APPROVED SITE PLAN: FEBRUARY 2023

90% SITE PLAN: DECEMBER 2023

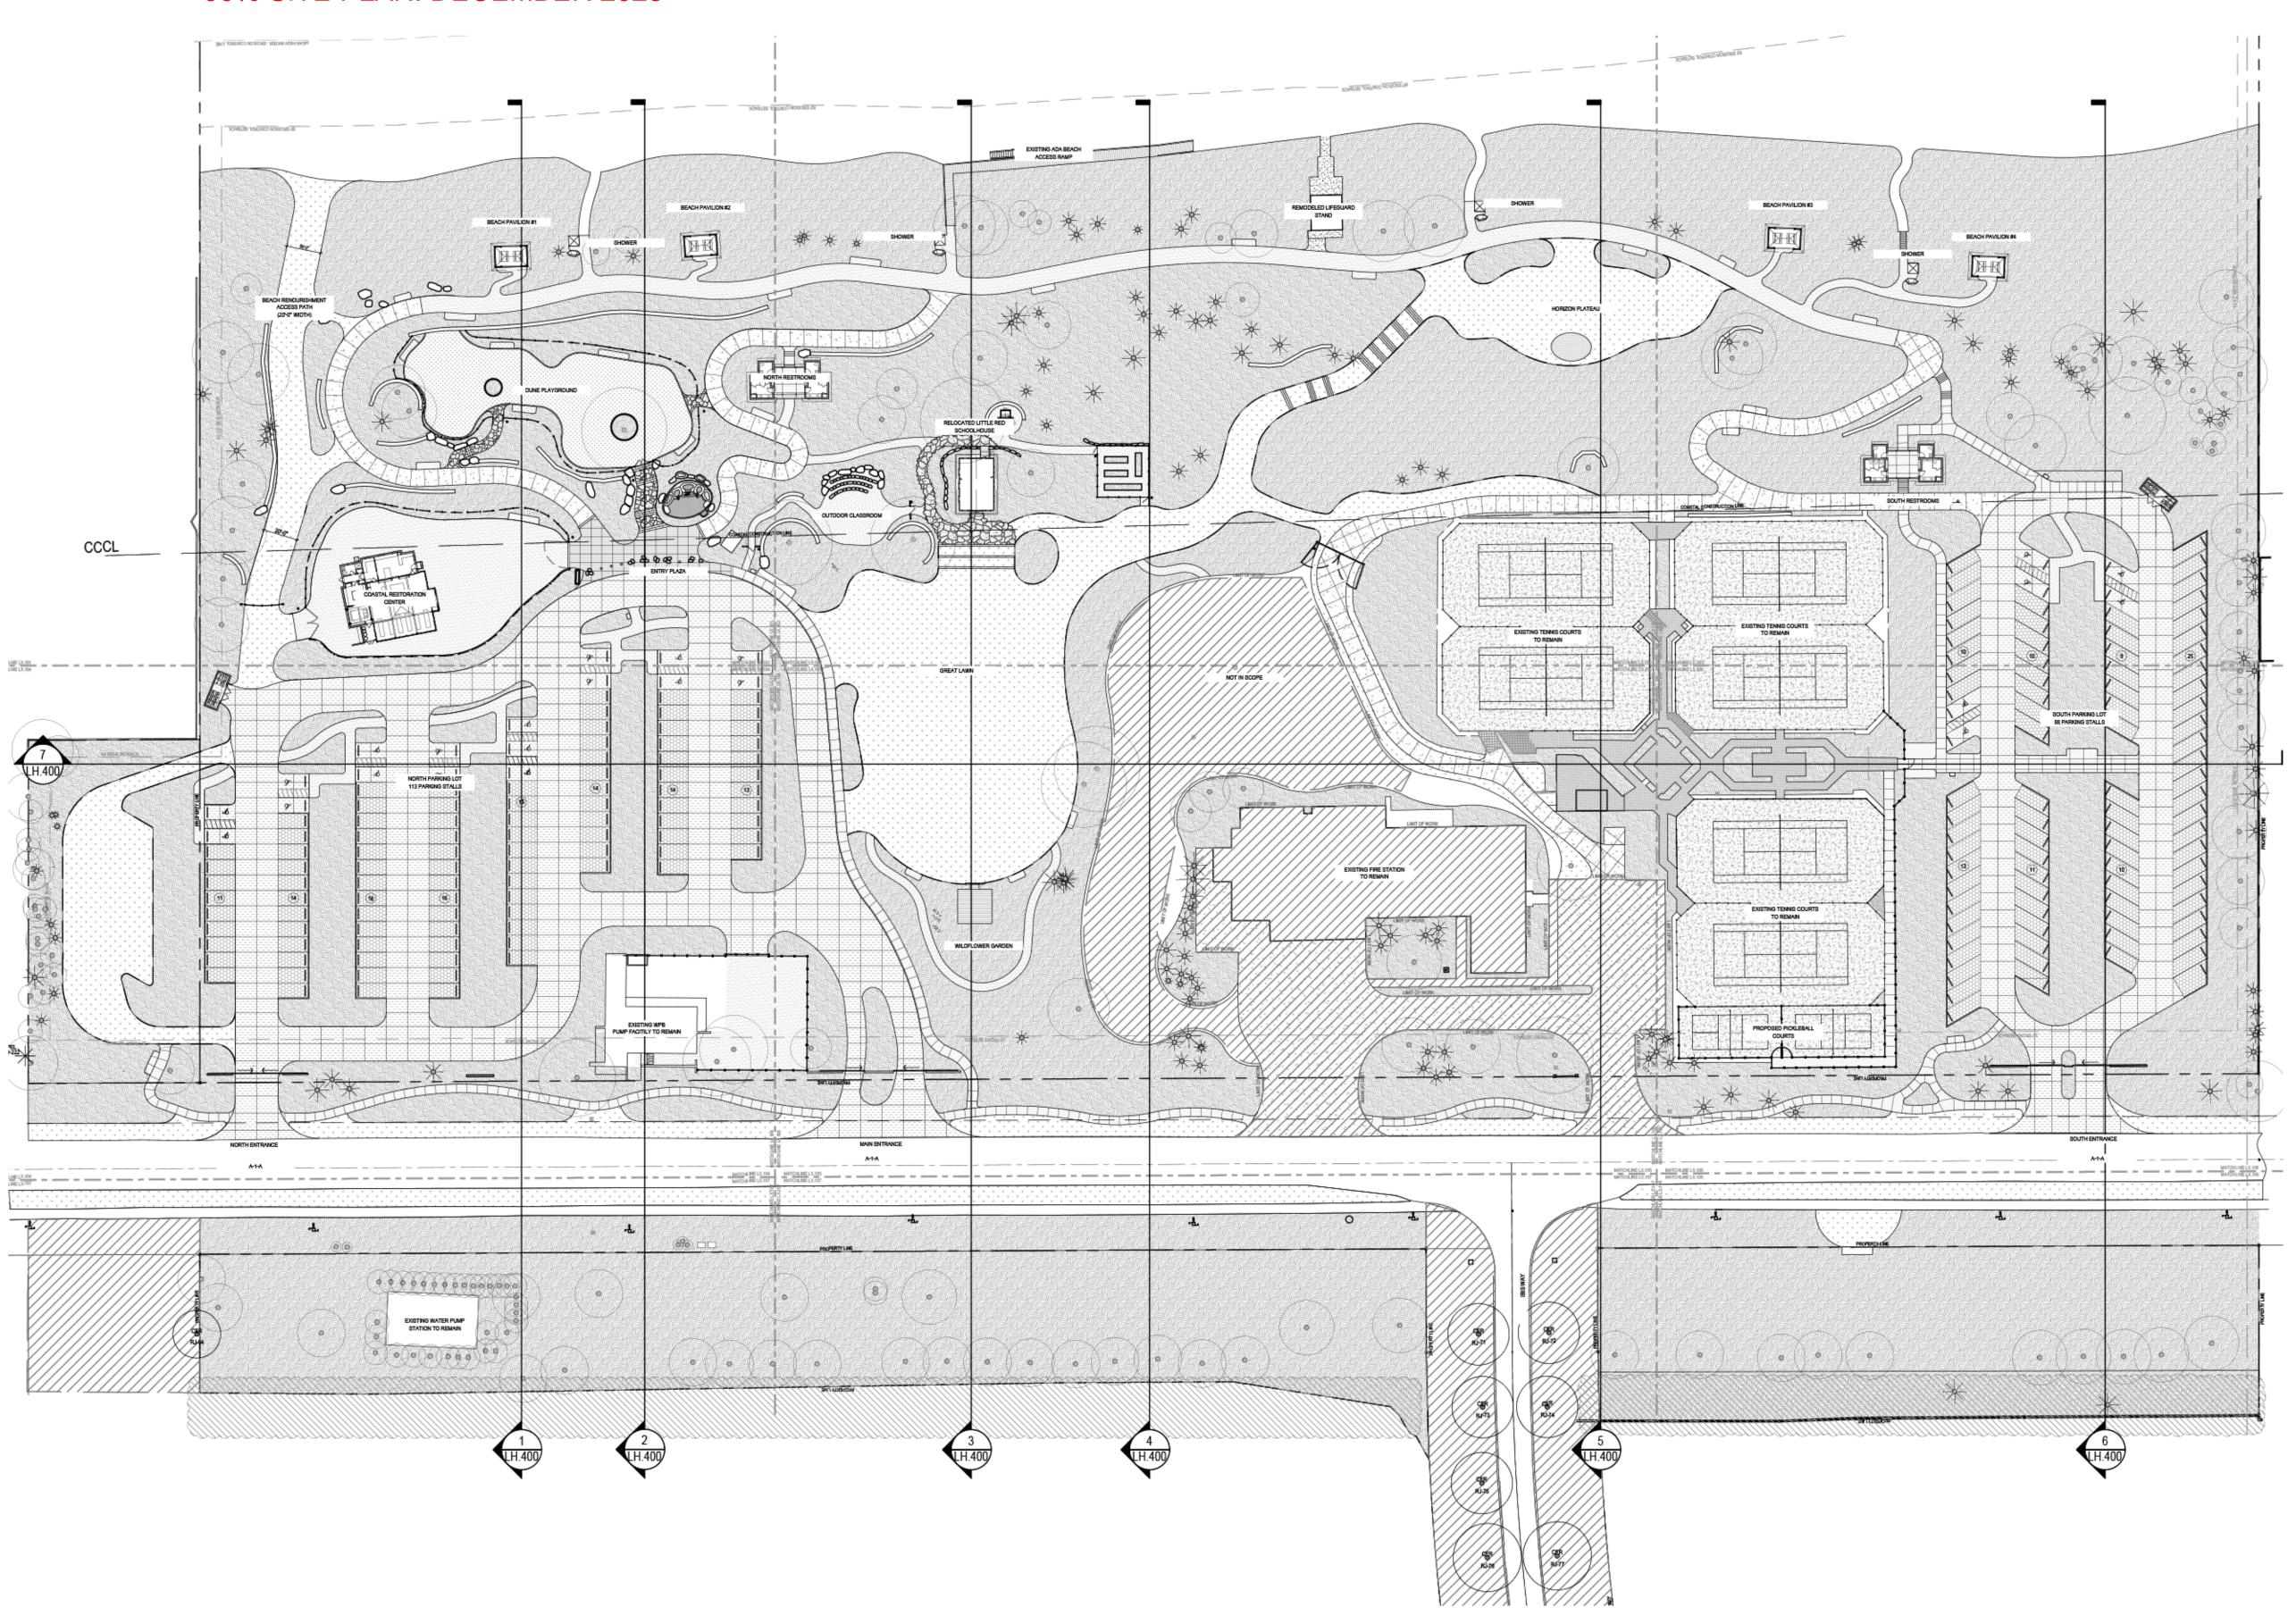
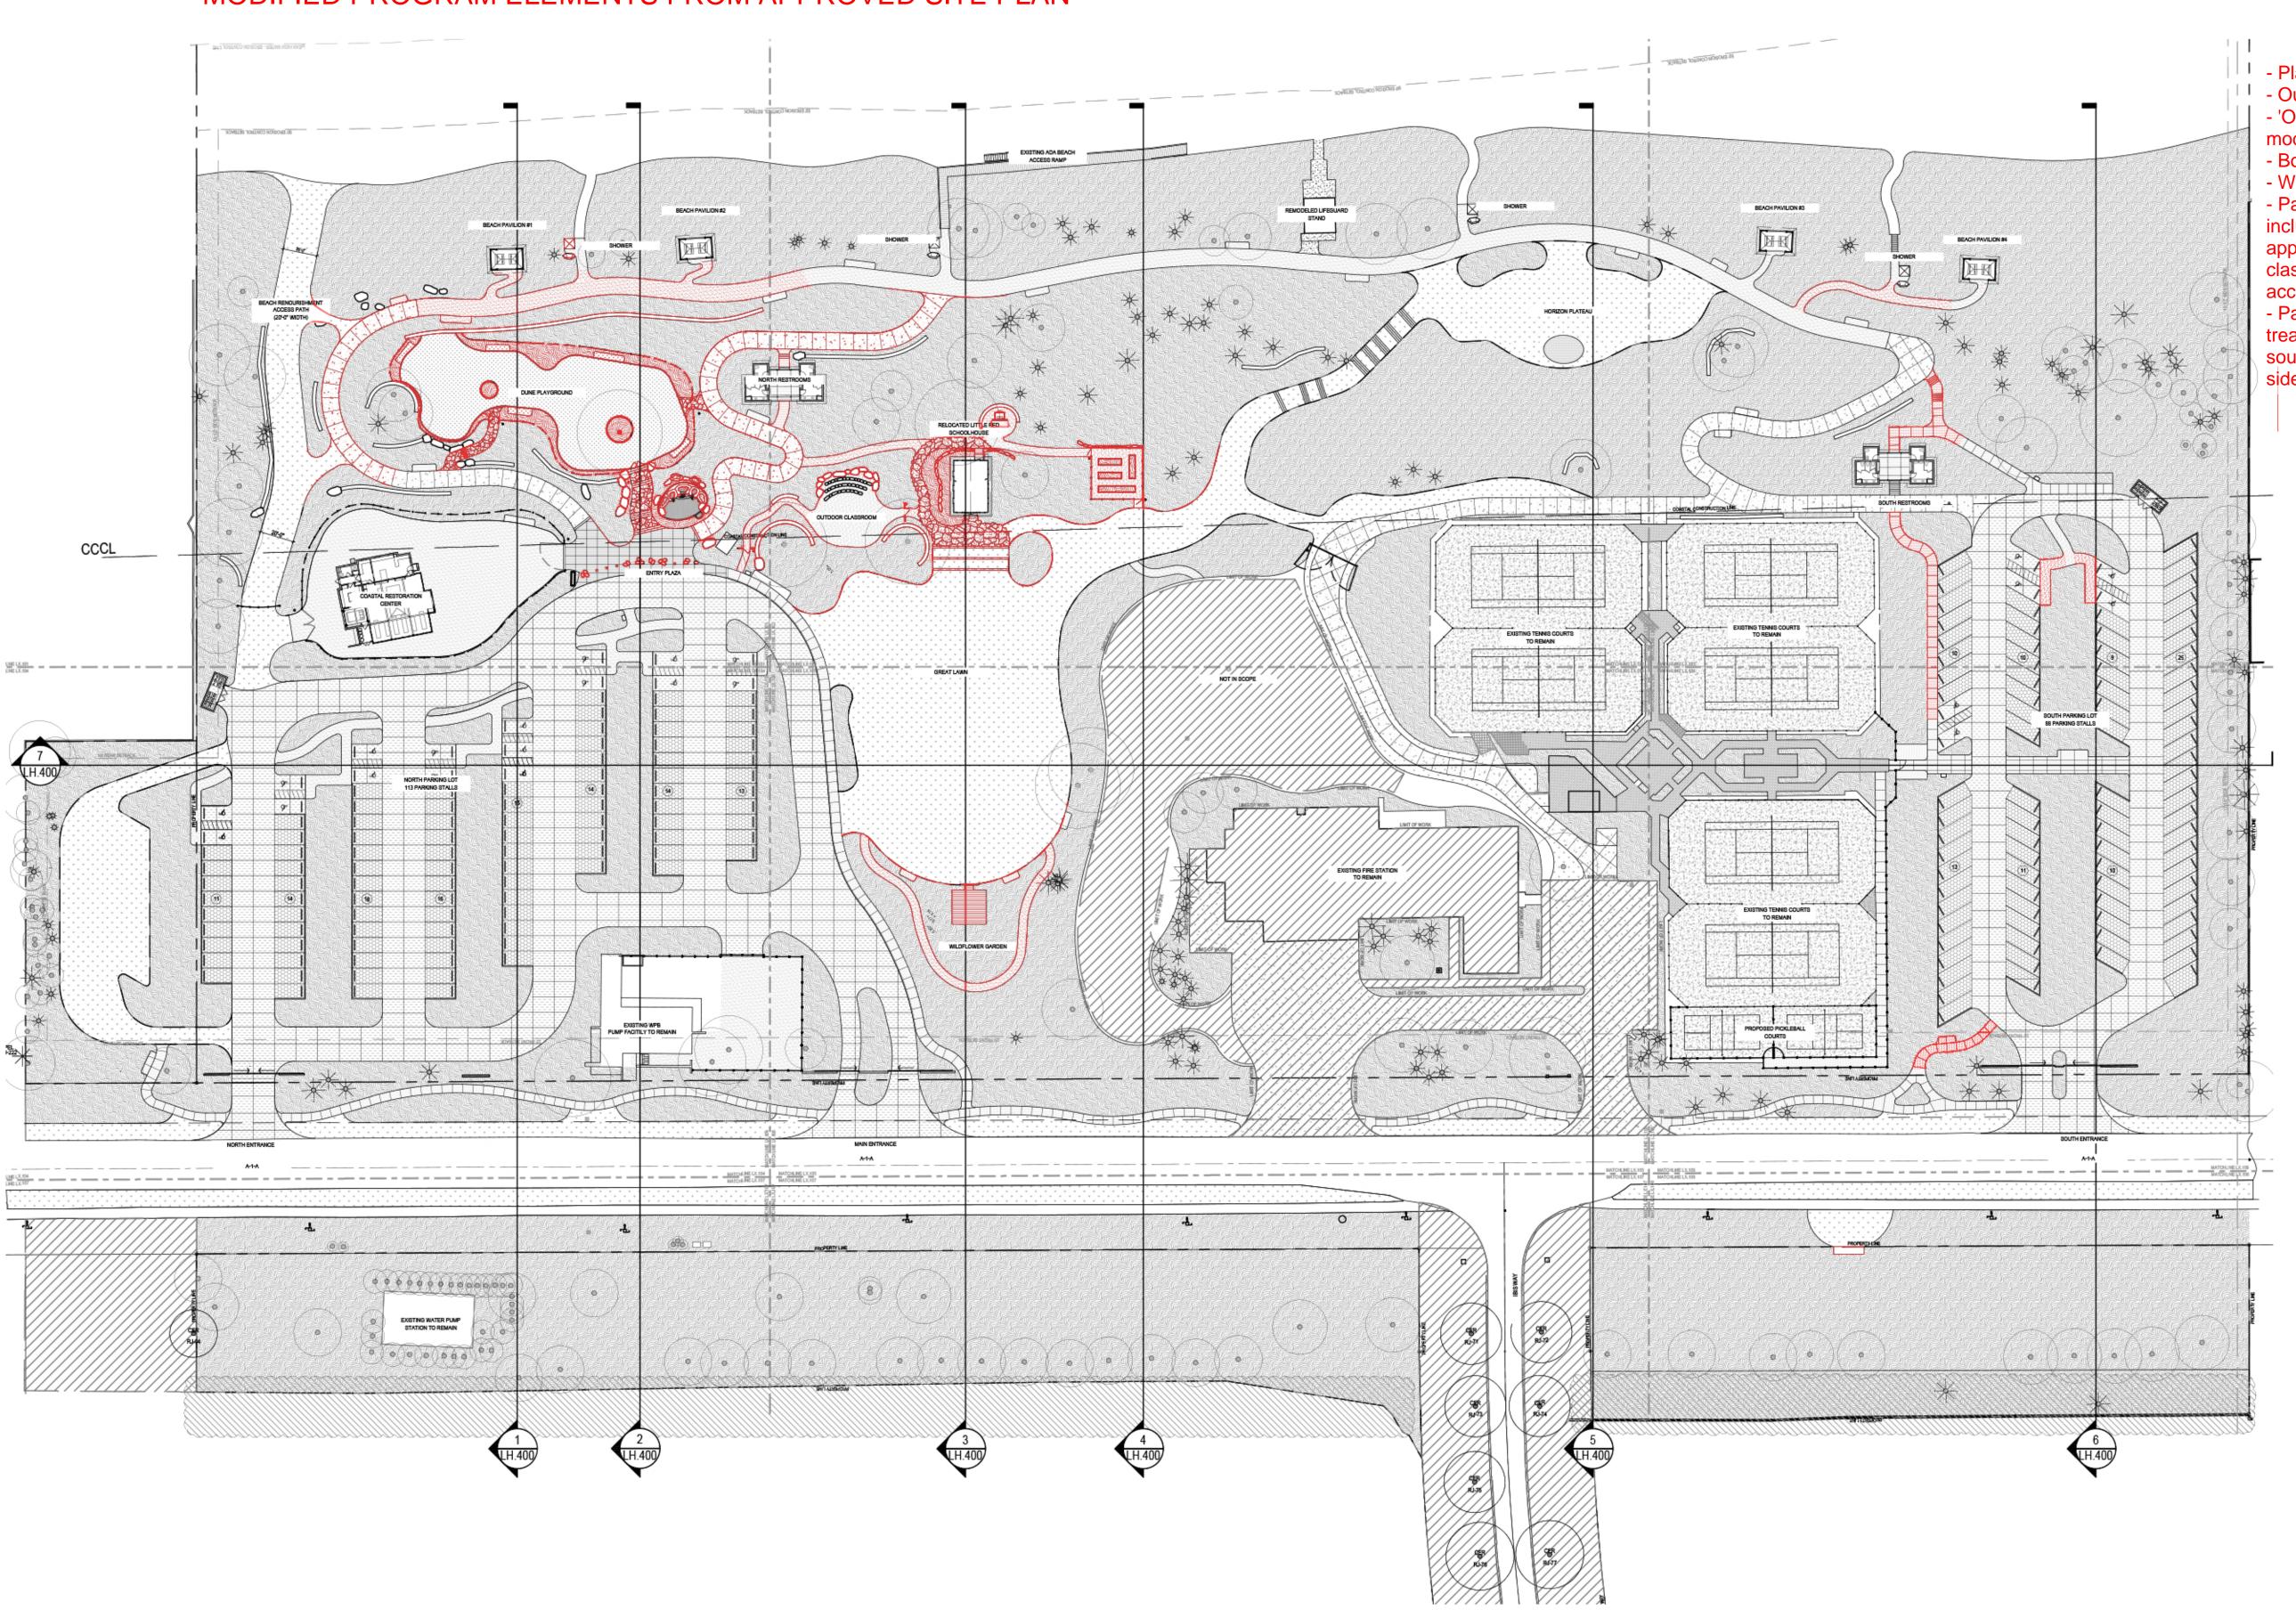
PROGRAM ELEMENTS REMOVED FROM APPROVED SITE PLAN

- North entry to playground removed
 Water feature basin removed (one of two)
 Interior walkways removed to accommodate stormwater treatment.
 - -- Oak Terrace removed
 - Sidewalk connection across A1A removed (to be completed under separate FDOT project)

MODIFIED PROGRAM ELEMENTS FROM APPROVED SITE PLAN

- Playground extents massaged
 Outdoor educational garden added
 - 'Out-house' A/C structure relocated due to grading modifications.
 - Bollards and seating boulders added to entry plazaWildflower garden pathway and overlook added.
 - Pathways modified to accommodate ADA accessibility including: dune crest approach, outdoor classroom approach, access to beach pavilions, outdoor classroom and LRS access, south restroom building
 - access, ADA parking access.

Pathways modified to accommodate stormwater treatment: South parking walkway from tennis center to south restroom building and south parking to R/W
